SERVICE No. 1131 BULLETIN

Date: August 18, 2003

**INSPECTION OF "CAST" MAIN LANDING GEAR
STRUT CYLINDERS (P/N's 65319-002, -003, & -004)**

Figure 1
Inspection Area

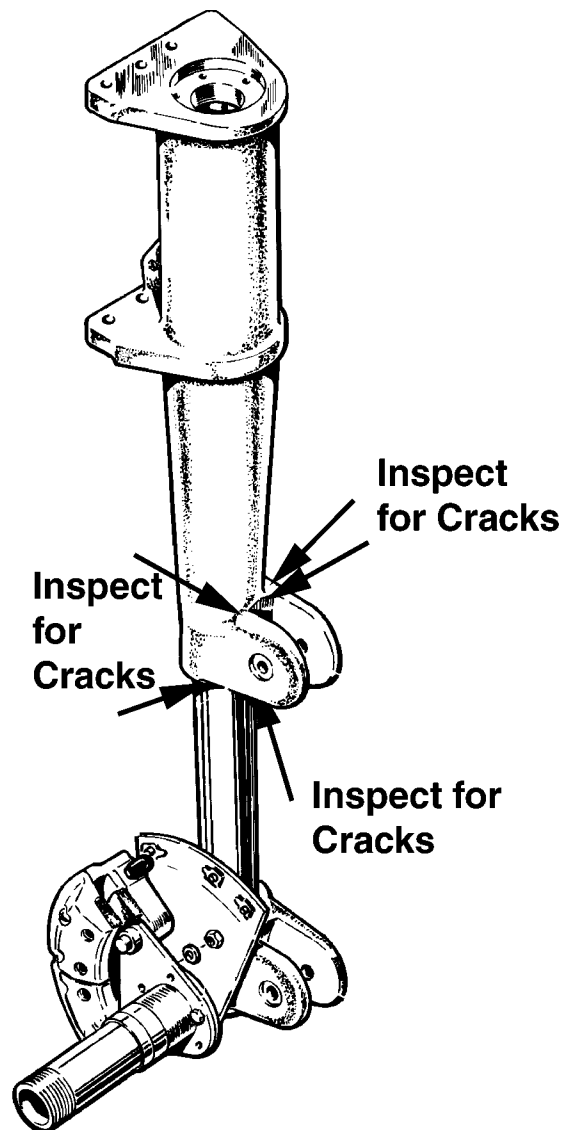
1. Thoroughly clean the area to be inspected as indicated in Figure 1 using a suitable cleaner.
2. Using a 10X power magnifying glass, visually inspect the gear cylinder top and bottom radii at the torque link attach lugs for cracks (Ref Figure 1). If no cracks are found by visual inspection, proceed to Liquid Penetrant Inspection per AC43.13-1B Chapter 5, Section 5 to check for cracks. Strip the paint and primer from the area to be inspected using a commercially available chemical paint stripper taking care only to remove paint and primer from the inspection area.

3. If a crack is detected, prior to further flight, replace the "cast" main gear strut cylinder with the "forged" main gear strut cylinder per the applicable Aircraft Maintenance Manual (See the "Material Required" section for applicable part number to order). Installation of the "forged" main gear strut cylinder in both the right hand and left hand gear position eliminates the need for the 100 hr repetitive inspection requirement for the aircraft.

4. If no cracks are detected, thoroughly clean the surfaces and touch-up paint and primer removed during the inspection process.
5. Make an appropriate logbook entry indicating compliance with this Service Bulletin.
